8/4/04 Notes:

B00149156 OK TO

SIGN - PROPOSED BARN

JAY THORNTON 840 WINDRIVER DR.

PLAN NOT TO SCALE

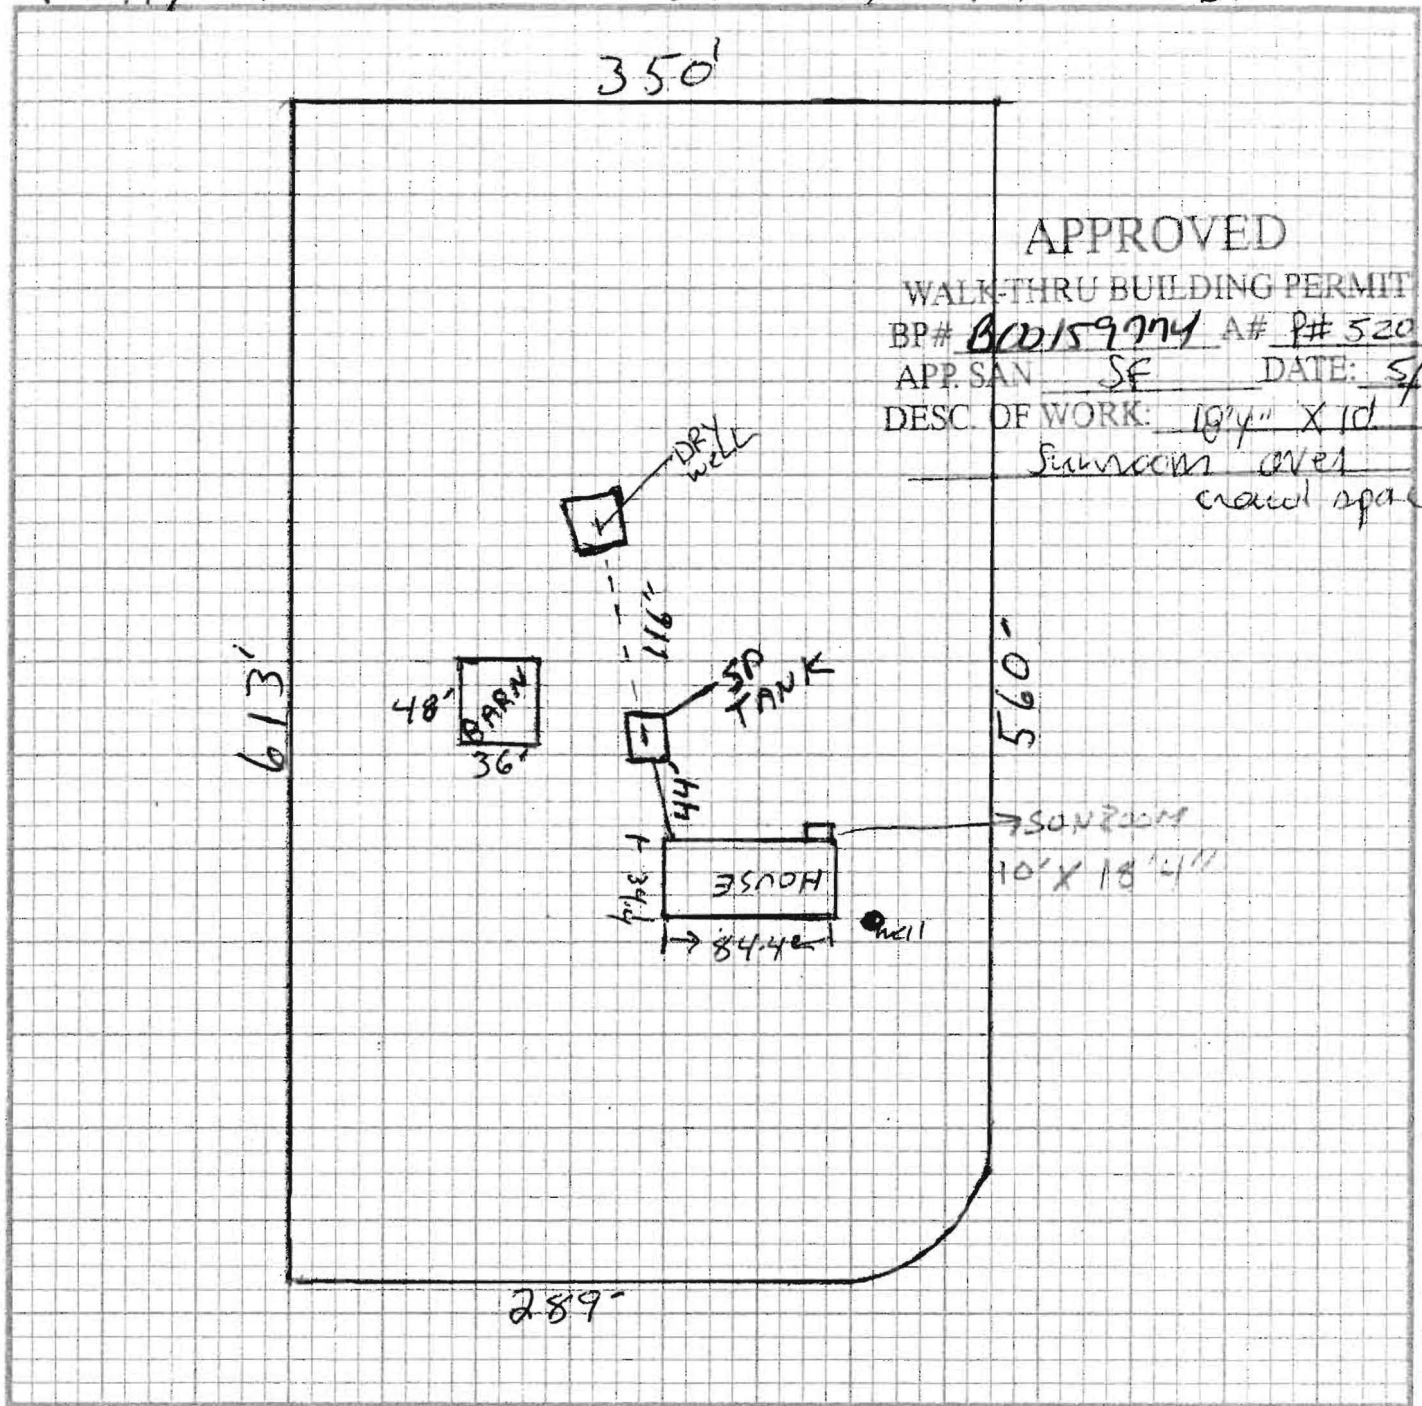
S.T. inlet 2' NOTES say 4', however dry well is not full & soils around dry well accepting effluent.

Measuring 120' west & 115' down, which follows property/fence line. Anger Holes (A) & (B) confirm acceptable soils from ground surface to at least 8'. No surrounding wells A CONCERN.

Approx 5,000 sq ft of USEABLE AREA AVAIL FOR future SEPTIC REPAIR.
